PLAN 1 The Clayton - LH

29 WS - 217 Salem Village Dr., Fuquay Varina, NC - 27526

2-15-24 - Initial Redlines - JJ

THE CLAYTON - LH
Cover Sheet 'Low Country'

S-1.2.3

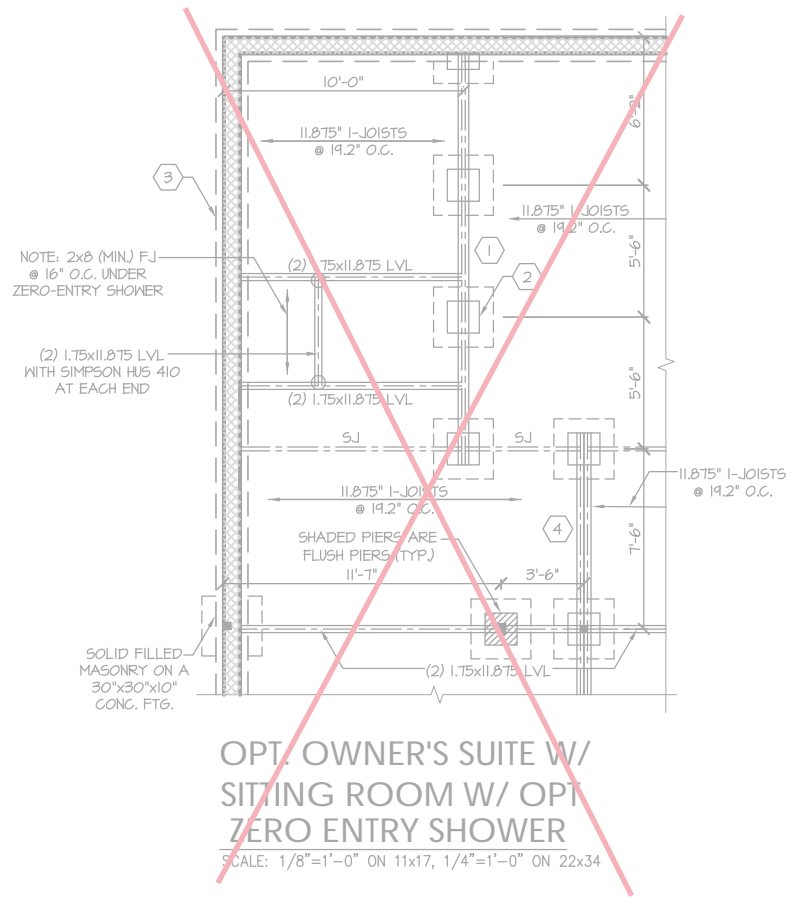
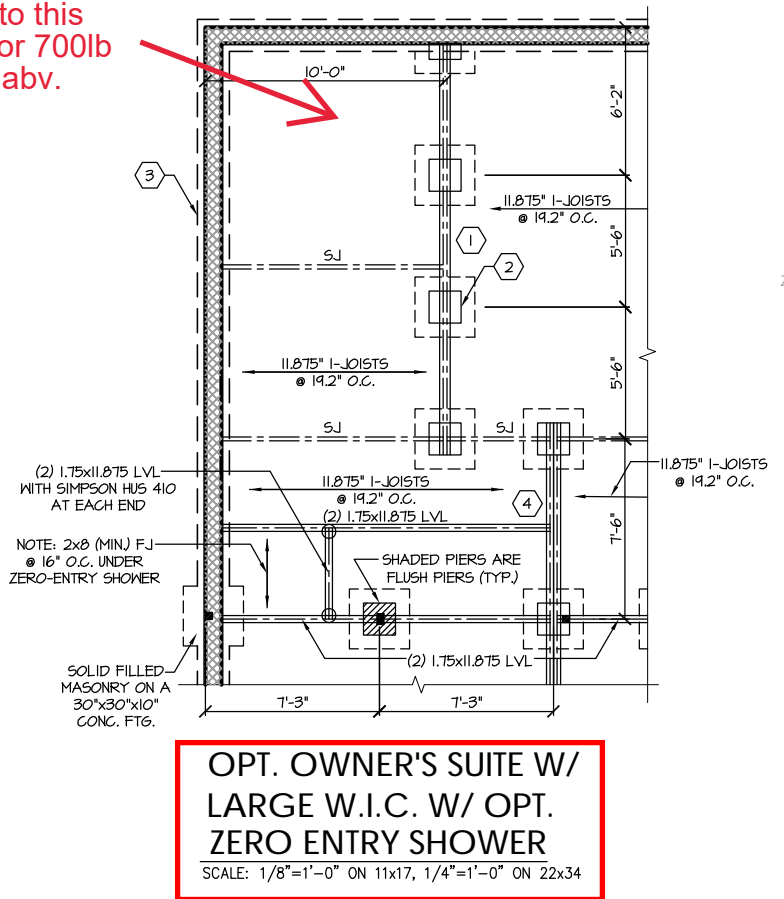
Add extra joist to this are for 700lb safe abv.
